CALGARY
RIVER
VALLEYS

**Regarding Proposed Outline Plan – Alpine Park
LOC2017-0378; CPC2020-0786; Bylaw127D2020**

Five Main Categories of Concerns:

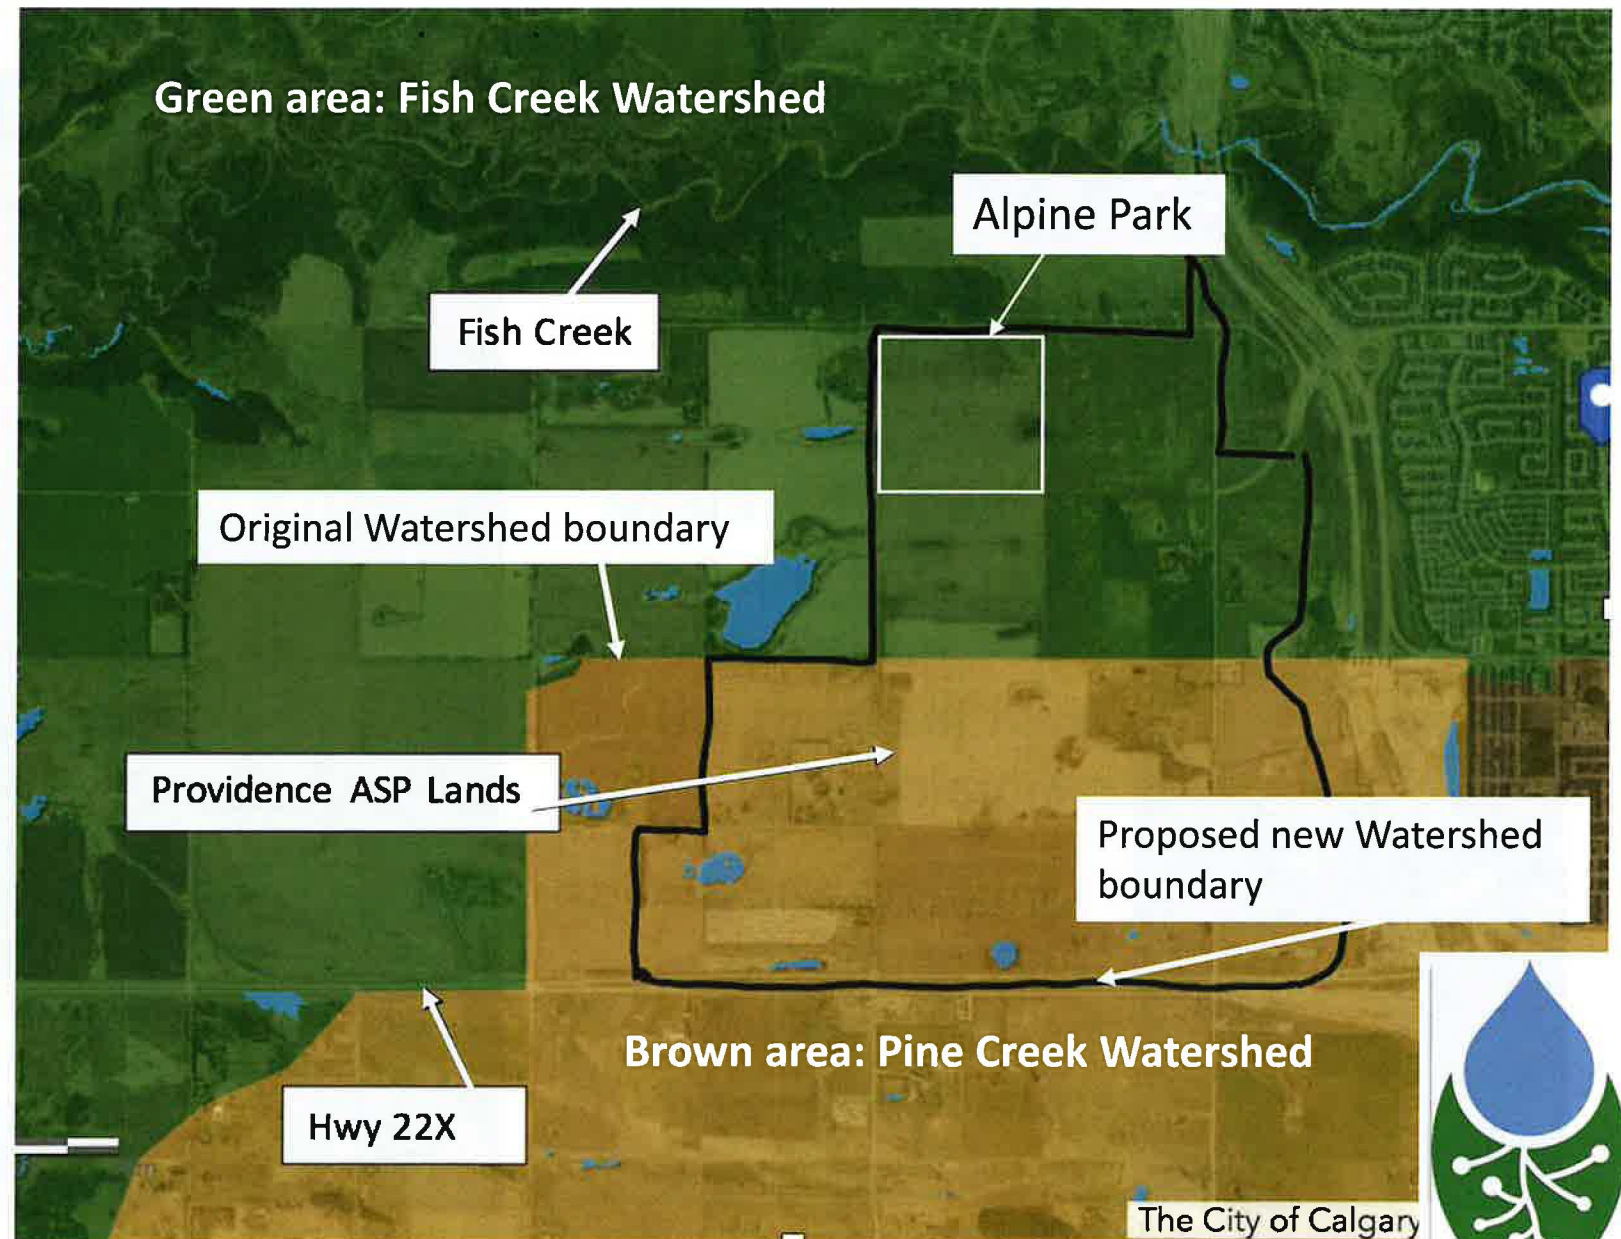
Category of Concern	Suggested Action
Re-Drawing Watershed Boundaries -- Fish Creek & Pine Creek	Detailed study required of anticipated impacts on Fish Creek & Pine Creek → diverting all surface water from the ASP lands into Fish Creek instead of approx. half to Pine Creek

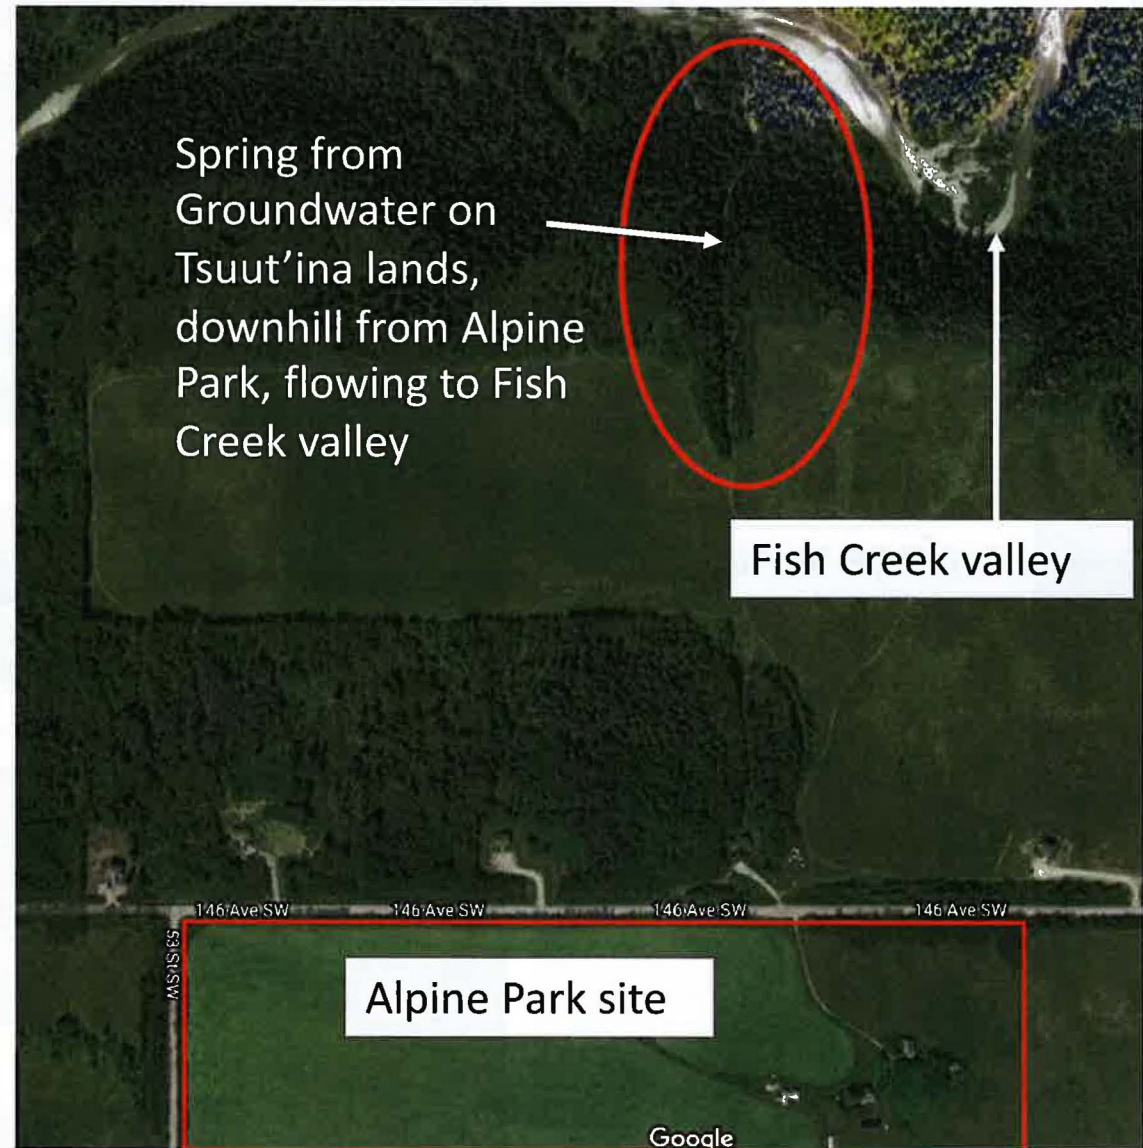
Category of Concern	Suggested Action
Sub-surface Groundwater	<ul style="list-style-type: none"> - Ensure pre-development groundwater flows downhill from Alpine Park to the Fish Creek valley, including Tsuut'ina lands are maintained - Complete and publish study of impacts of proposed changes to groundwater regime in area

Dried out wetland

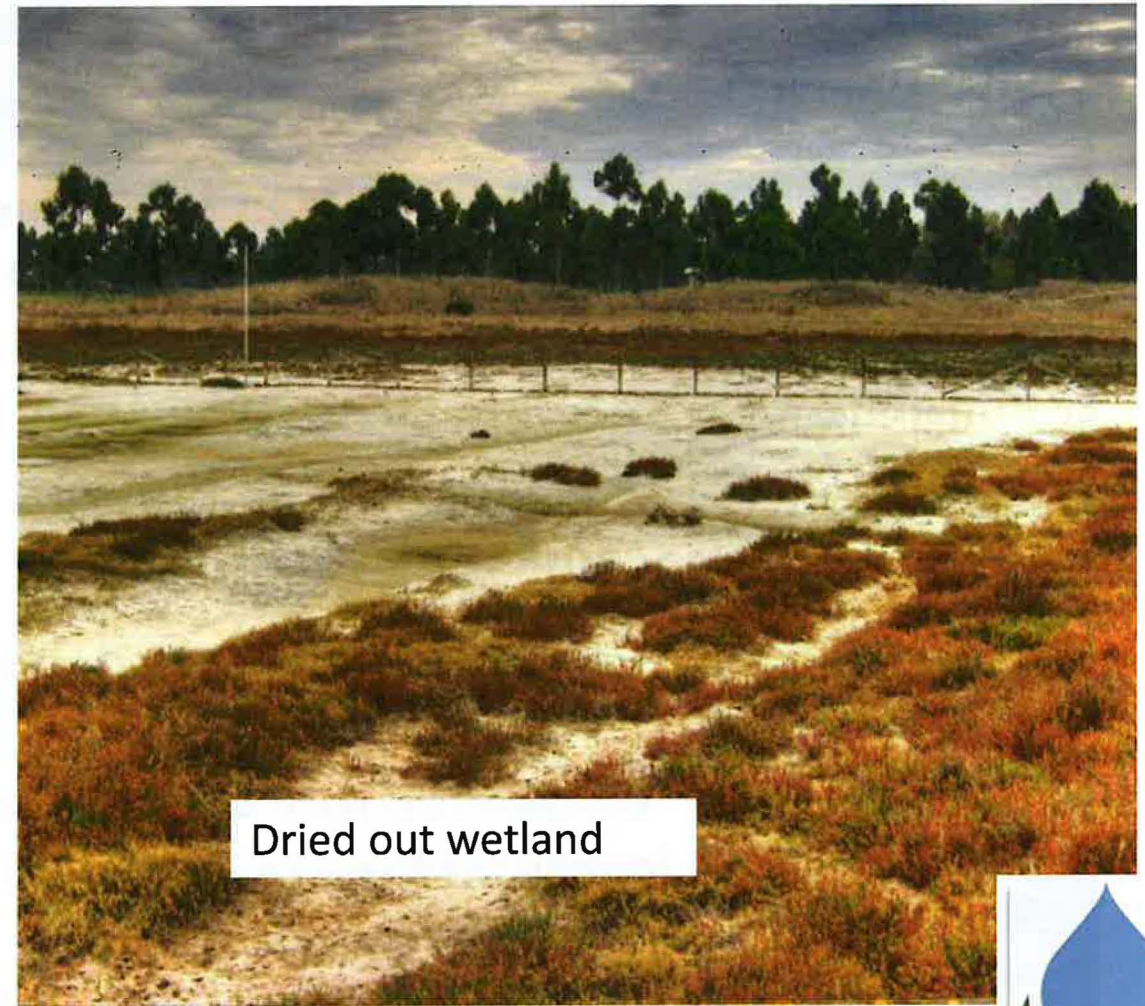
Category of Concern	Suggested Action
Cumulative Effects	<p>Clearer understanding required of cumulative impacts from:</p> <ul style="list-style-type: none"> - stripping off surface water & wetlands from Alpine Park & other Providence ASP parcels, - no replenishment of groundwater, especially with up to 70% impervious surfaces allowed within Area Structure Plan (higher than normal)
